This document is submitted to the Department of Planning, Housing and Infrastructure (DPHI) in support of the Response to Submissions (RTS) to the State Significant Development Application (SSDA) (SSD-94006708) for a mixed use development at 15-21 Cottonwood Crescent, Macquarie Park.

The Proponent has received feedback from the Department of Planning, Housing and Infrastructure (**DPHI**), Transport for NSW (**TfNSW**) and City of Ryde Council (**Council**), following the submission of the transport impact assessment report as part of the EIS submission. The responses are identified and references are provided to show where they are addressed in this document.

APPENDIX A – UPDATED SWEEP PATH ANALYSIS

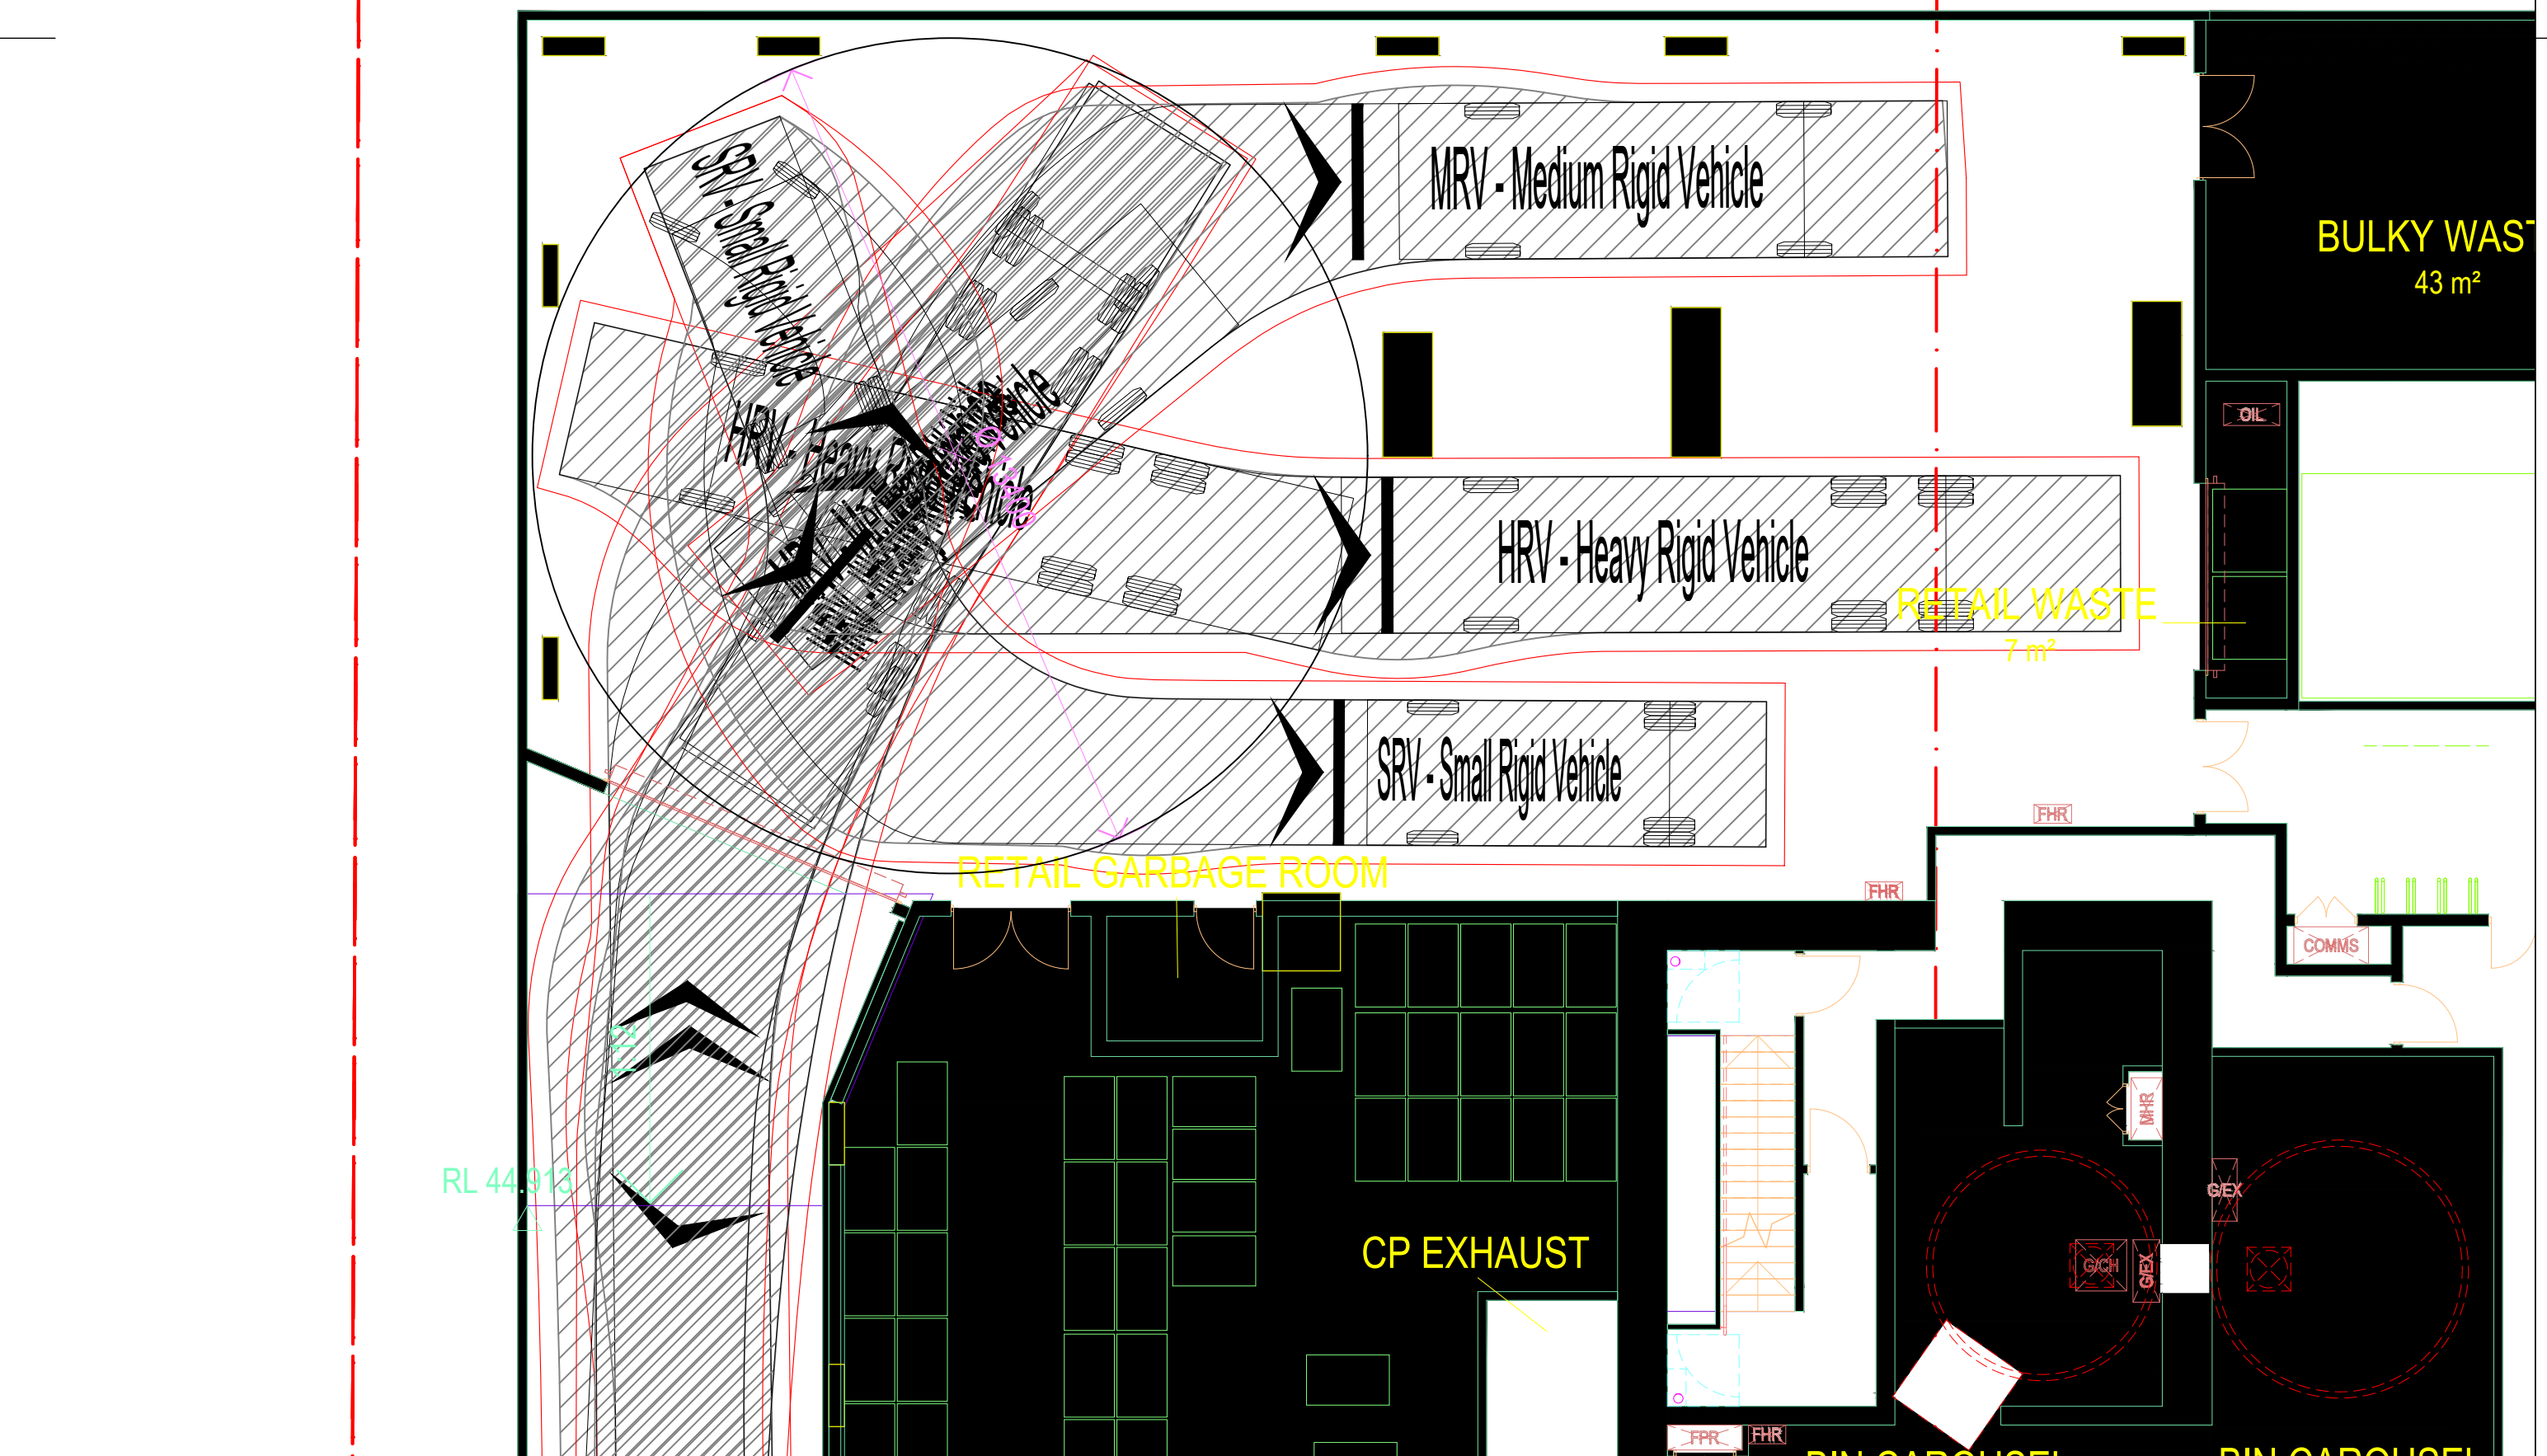
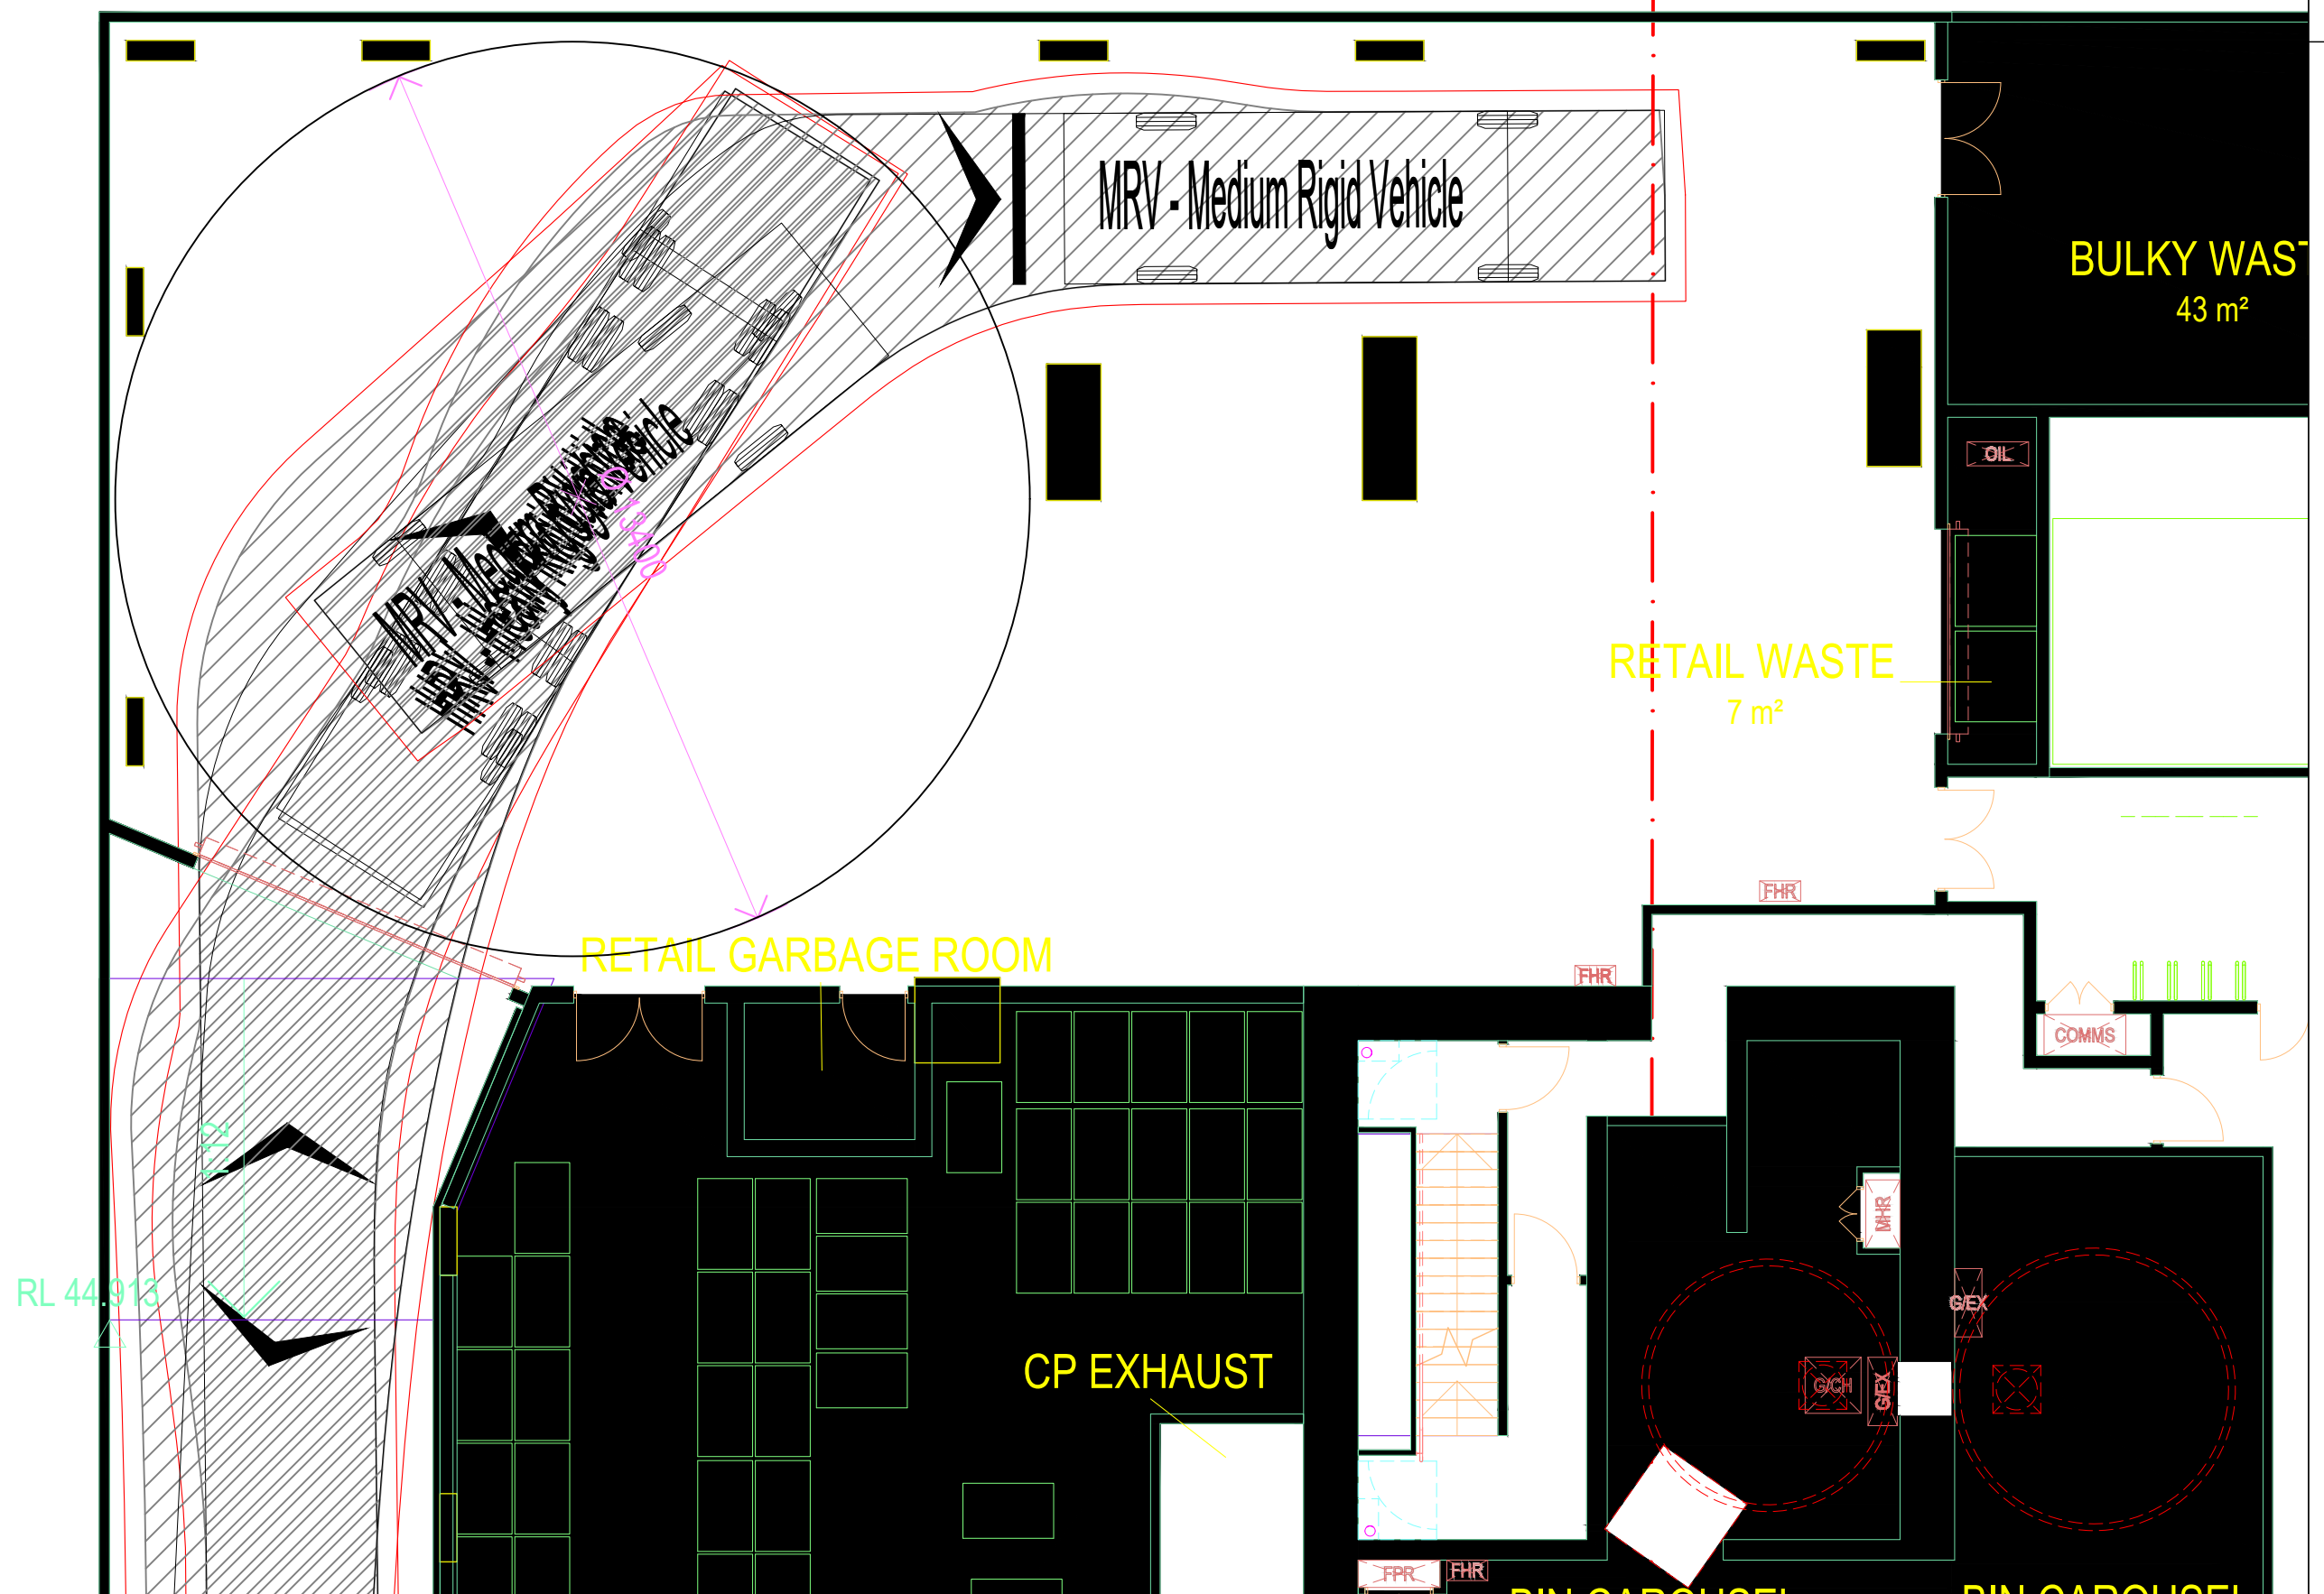
Agency	Agency Comment	JMT Consulting Response
Council – Waste Management	Provide swept paths for a heavy rigid vehicle in accordance with AS 2890.02 to ensure waste collection vehicles can safely access the site for servicing. - The swept paths provided cannot be used to clearly identify the proposed transit of the 12.5 metre HRV utilised for waste collection. Swept paths must be clearly identified for each vehicle type. - The paths detailed in the Traffic Impact Assessment do not clearly show the vehicle body therefore conflicts cannot be determined. - The provided swept paths do not clearly demonstrate whether the proposed turntable is unobstructed from bins doors, or support structures. This space must remain clear of all obstructions to support safe and efficient servicing.	Full scale swept path plans are provided in Appendix A of this document, including for a 12.5m HRV utilised for waste collection. The swept paths include both the vehicle body and clearance envelope as required under AS2890.2. The swept paths confirm that the proposed turntable is unobstructed from bins doors, or support structures.
